Duke Energy Carolinas, LLC
Response to Comments on
NPDES Permit Application
William States Lee III Nuclear Station
SC0049140
December 22, 2011

Comments on Volume I

Figure 18 – Blue iso-surface showing steady-state $\Delta T = 5^\circ\text{F}$ plume for Scenario 3.

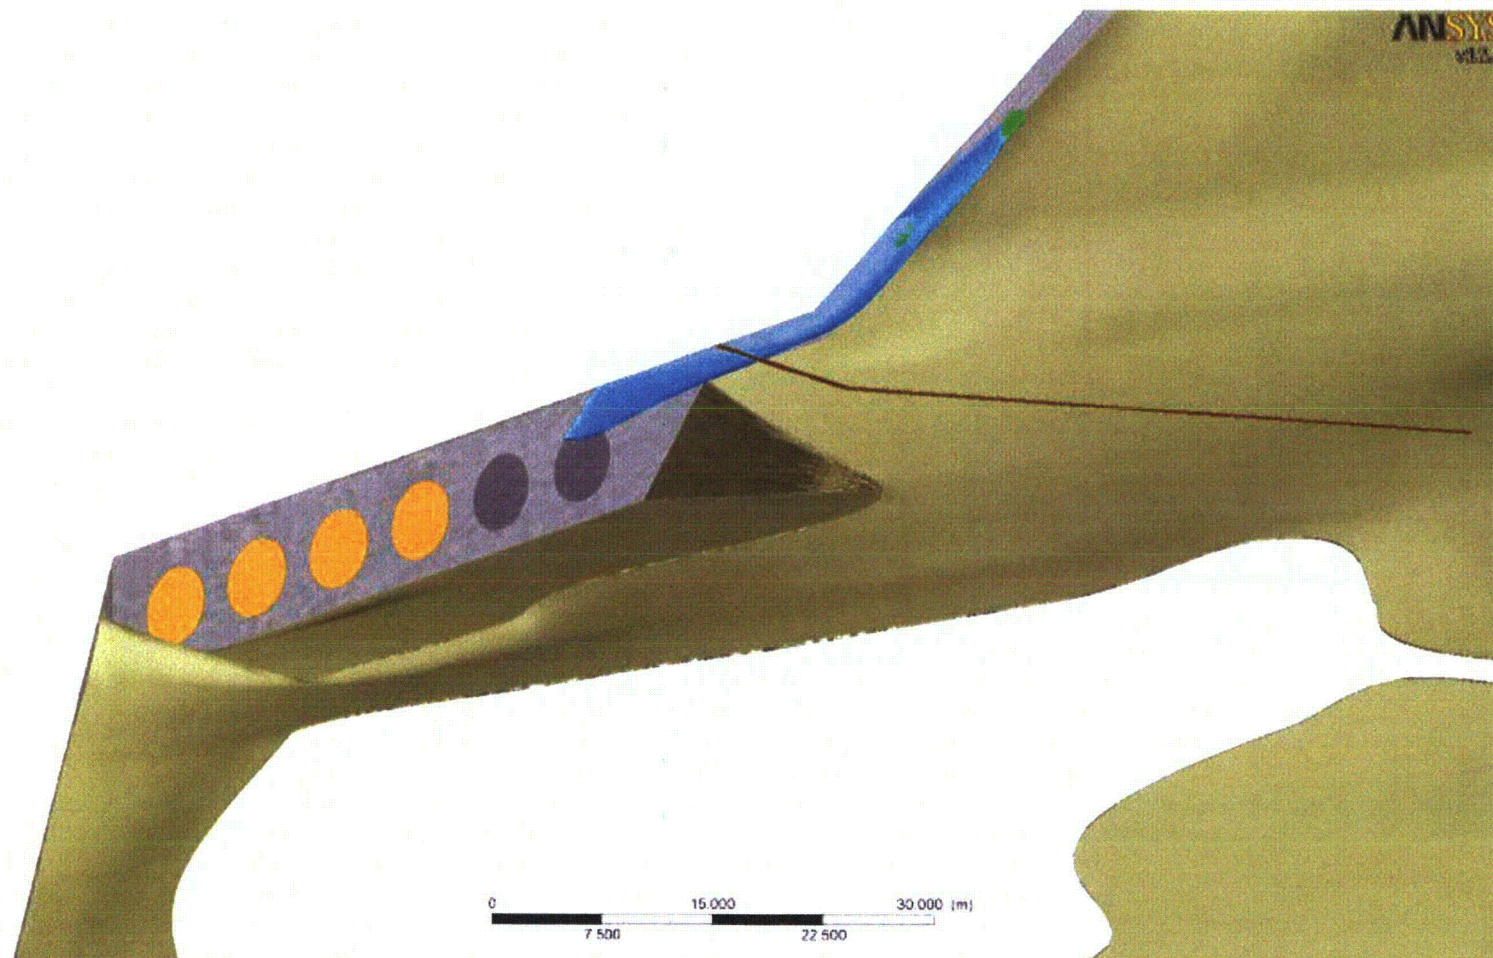
- 3) Part VI Mixing Zone Request Pages 7, 10, and 14 – Was the temperature rise modeling referred to on page 7 conducted at worst case winter conditions? The results of research by Dr. Roberts reported on page 10 included temperature rise modeling for winter conditions, but this research was reportedly for the purpose of optimizing the diffuser design, not to address NPDES mixing zone requirements. In addition, Dr. Roberts's research was based on a discharge temperature of 91°F, not 95°F (p.16). Please provide information showing that the temperature rise criterion of 5°F has been considered at worst-case winter conditions.

The maximum delta T occurs during the colder ambient months. During colder months the discharge will be less than 90°F. An additional model run was conducted for winter conditions to confirm that the 90°F plume presented in the mixing zone request is bounding. The model used a 26°F delta temperature, which was the largest delta temperature value provided in the Roberts report. The results of this model run are attached (Attachment 1). In summary, the greater than 5°F delta plume is very small and smaller than the projected greater than 90°F plume. Attachment 1 replaces the mixing zone report included in Volume I

of the August 2011 NPDES permit application for Part VI. Specifically, changes were made on pages i, ii, 14, 17, 18, 20, 21 and 22. Changes were also made to Figure 18 in the attached report.
